Section 96(1A) Modification Application (SSD 5169) – MOD 4

Horsley Drive Business Park, Burilda Close, Wetherill Park (Lot 5 DP 1212087)

Figure 2: Proposed Layout – Access Road

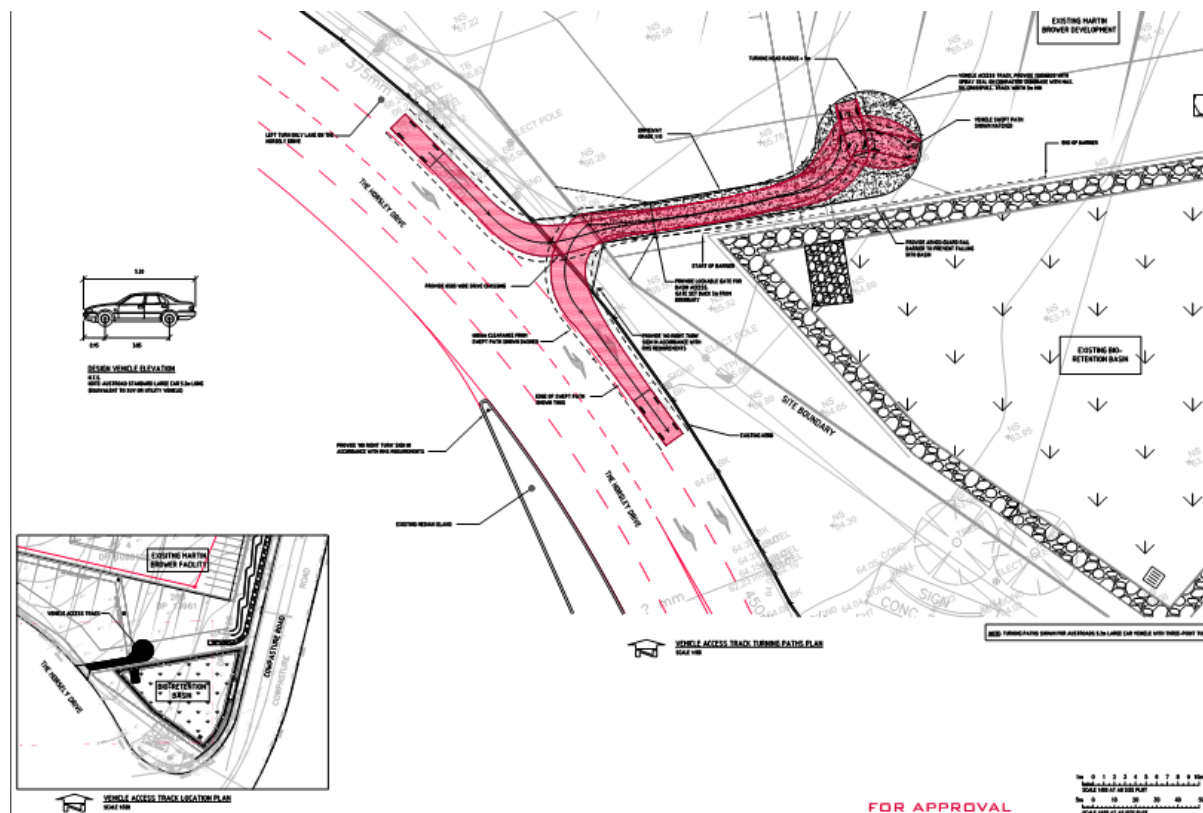
The proposed modifications have been brought about by the irregular access arrangements to the stormwater detention basin located at the corner of The Horsley Drive and Cowpasture Road. Access to the stormwater detention basin from Cowpasture Road is limited by walls and batters thereby modification is sought to create a crossover and driveway for maintenance purposes.

As evident in **Figure 1** and **Figure 2**, the modifications are minor and do not alter the aims or objectives of SSD 5169.
